Product Change Bulletin

03-20-2011

MiniMag, Magnum, GTX, XR

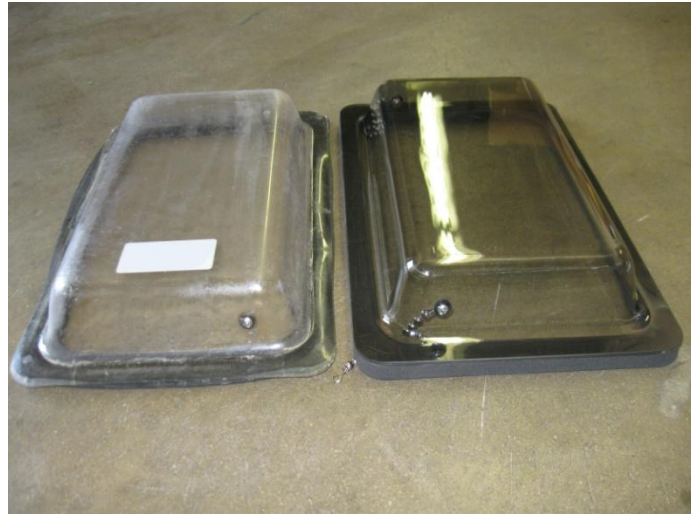
Warping or bending of the recovery tank lid

The changes made to the recovery tank lid are not only being tinted but it has a higher temperature resistance (270F vs 170F with clear lid). Also the tank lid gaskets have improved adhesion and the lids have more surface area for the gaskets to attach to.

Warped clear recovery tank lid, lid is not sealing.

190-1410D

This is a direct replacement of the clear plastic lid. Remove the 2 screws holding the recovery lid to the metal tank lid and replace with new lid.
